SR and PPI Jitter Budget Review Comment 162

John Petrilla,
Avago Technologies
June 2009

Amended Comment 162 and Proposed Remedy

TP1 J2, 5E-5, J9 & TJ vs DJ

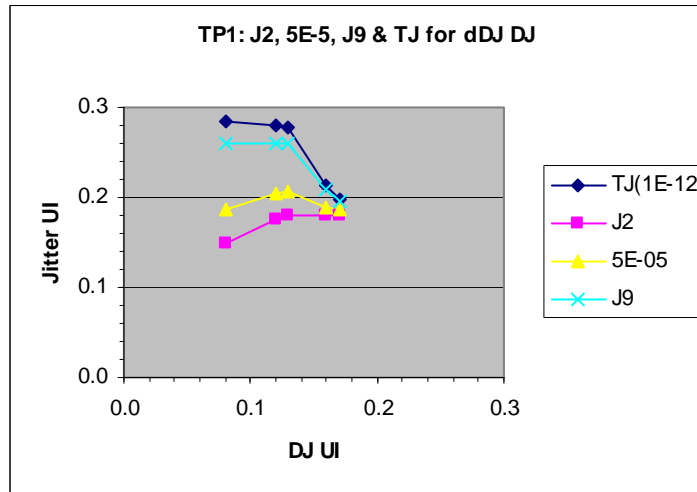
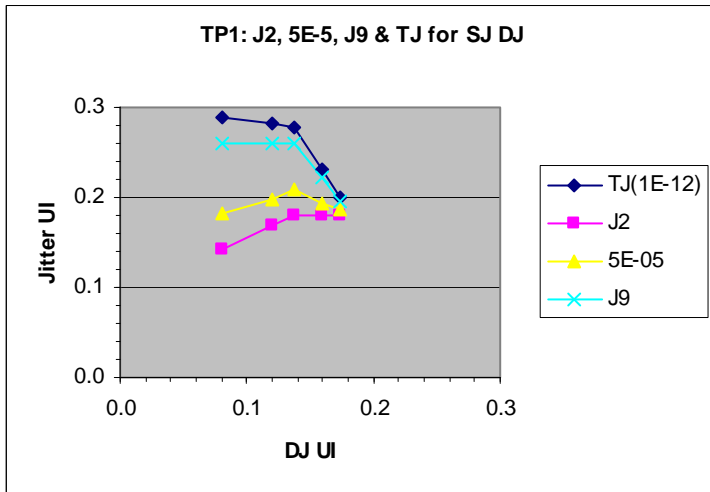
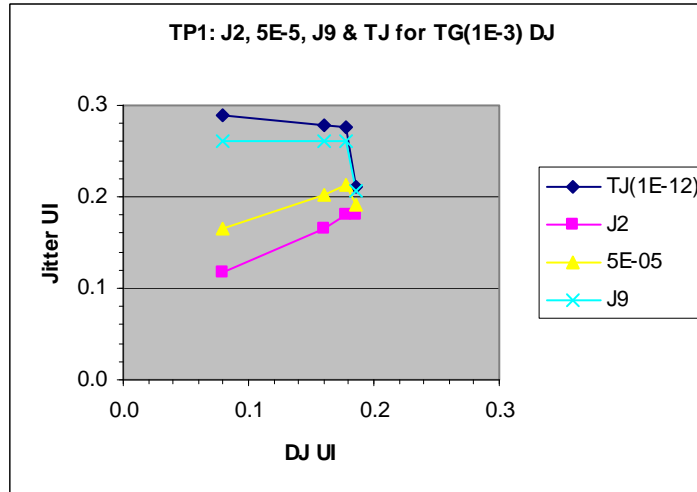
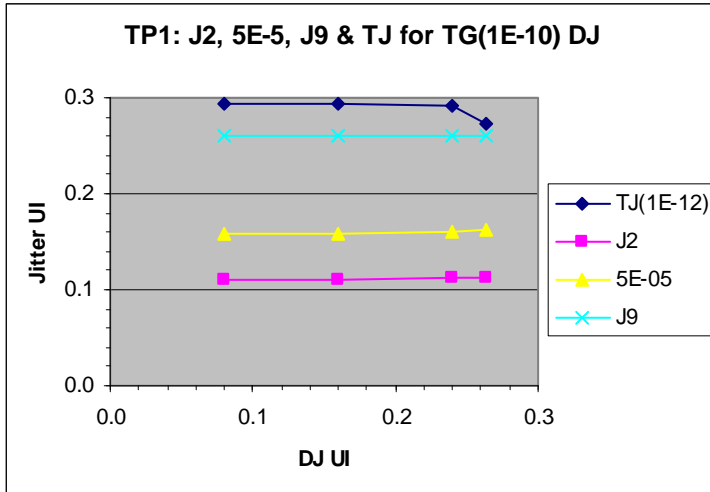
In the above, for a given DJ, RJ was increased until either J2 or J9 was at its max. Max values of TJ (0.294 UI) occur for low values of DJ. For high values of DJ and low values of RJ, TJ and J9 approach the max J2 limit.

TP3 J2, 5E-5, J9 & TJ vs DJ

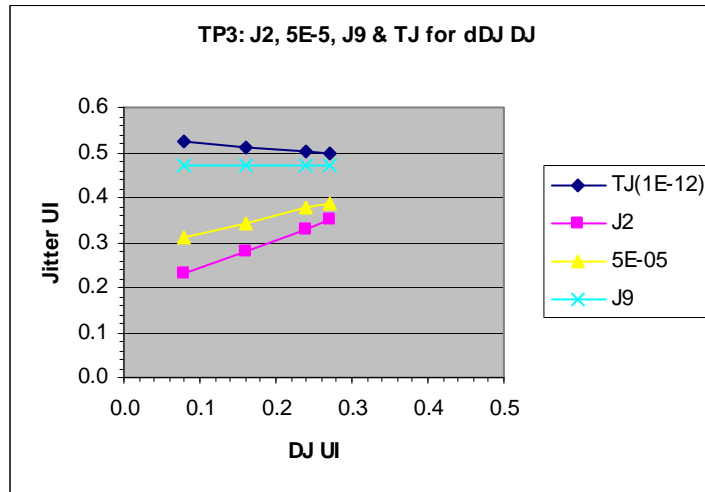
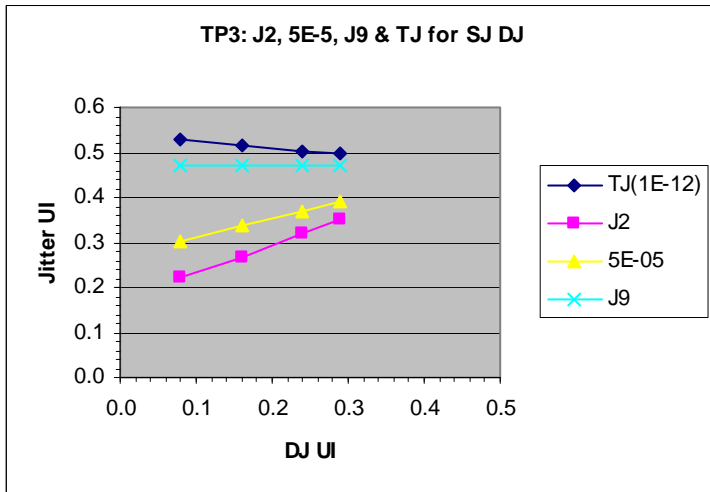
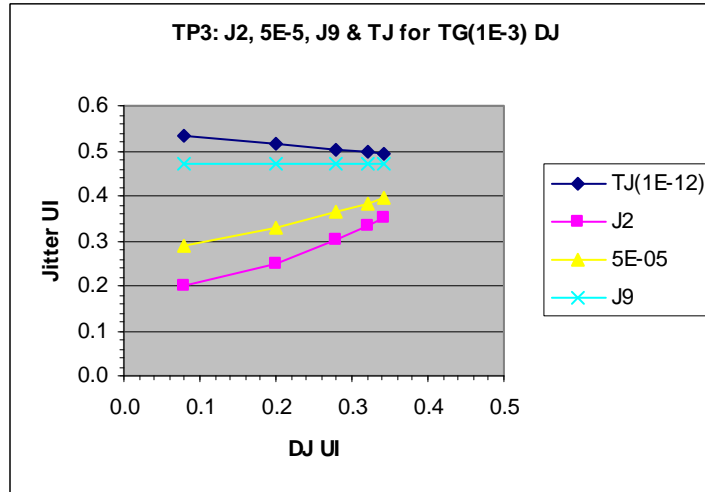
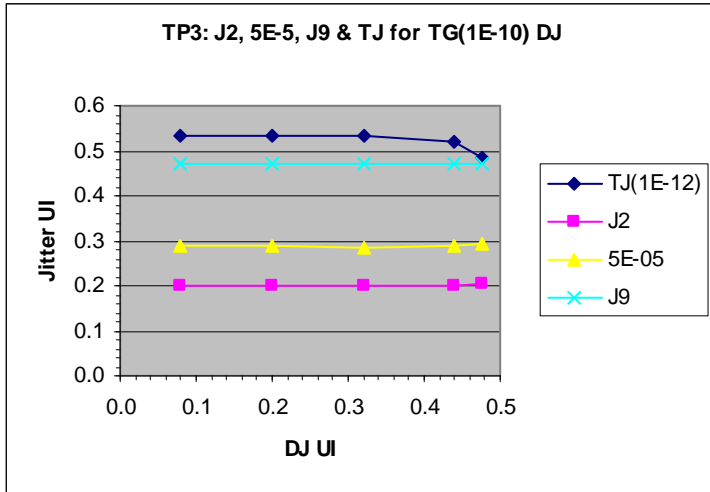
- At TP3, when J2 (0.35 UI) and J9 (0.47 UI) conditions are met simultaneously, TJ is estimated at 0.496 UI, higher than the expected 0.485 UI. However a TJ of 0.496 UI is in reasonable alignment with the upstream TDP test. Other combinations of J2 and J9 can yield a problematic max TJ overstress of 0.534 UI and should be avoided. Further review of the stressed receiver conditions shows an additional overstress in the applied vertical eye closure penalty (VECP). Relief for the combined overstress conditions is proposed by reducing the VECP condition from 2 dB to 1.9 dB.

In the above, for a given DJ, RJ was increased until either J2 or J9 was at its max. Max values of TJ (0.534 UI) occur for low values of DJ. For high values of DJ and low values of RJ, TJ and J9 approach the max J2 limit.

Suggested Remedy: In Table 86-8 change VECP from 2 to 1.9 and in Tables 86A-3 and 86A-4 change J9 from 0.63 to 0.62.

TP4 J2, 5E-5, J9 & TJ vs DJ

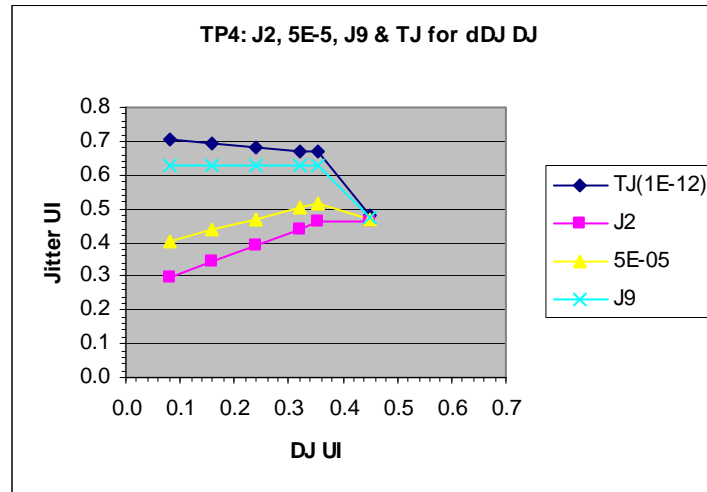
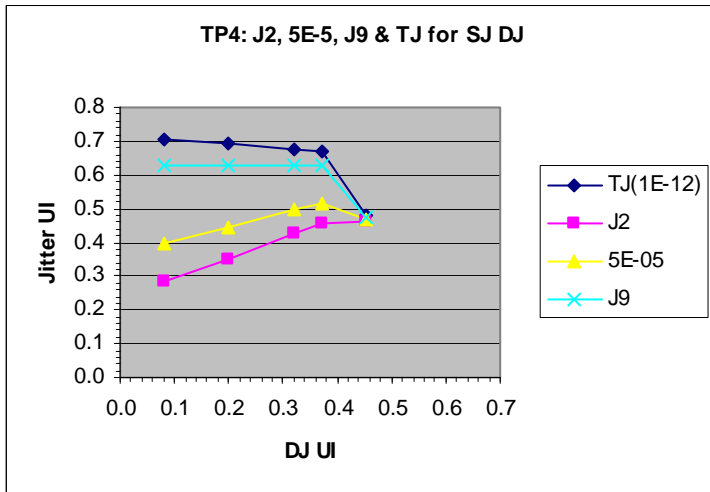
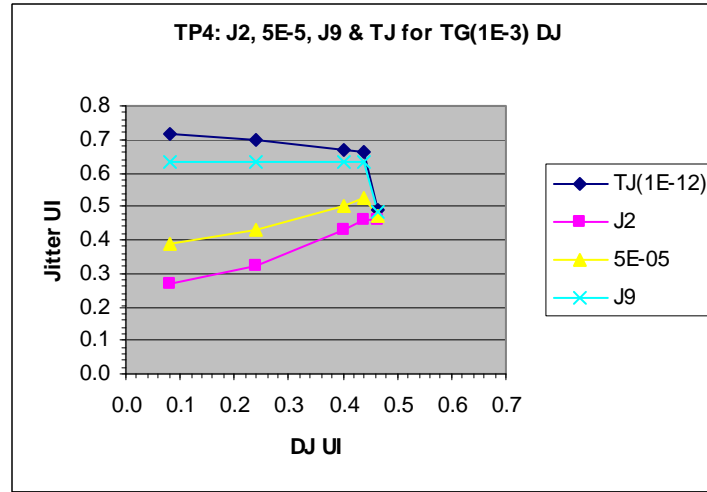
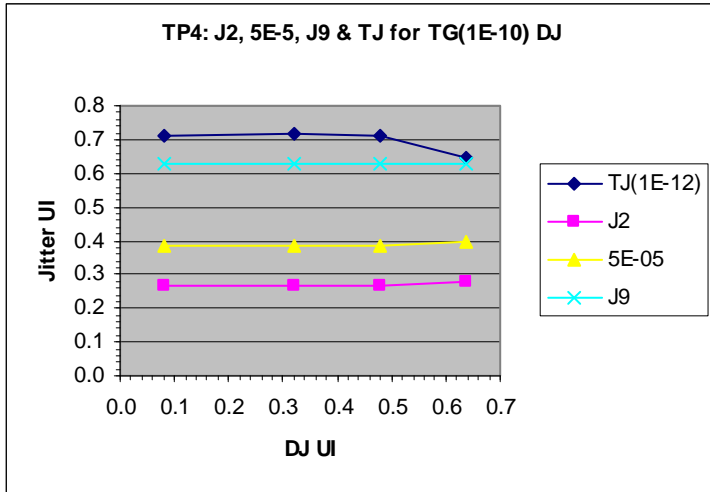
- At TP4, for the combination of J2 (max = 0.46 UI) X1 = 0.11 UI and J9 (max = 0.63 UI), max TJ is estimated at 0.716 UI. This is higher than the expected 0.68 UI and may place too heavy a burden on the downstream receiver. Relief is proposed by reducing max J9 from 0.63 UI to 0.62 UI to yield a max TJ estimate of 0.704 UI.

In the above, for a given DJ, RJ was increased until either J2 or J9 was at its max. Max values of TJ (0.716 UI) occur for low values of DJ. For high values of DJ and low values of RJ, TJ and J9 approach the max J2 limit.
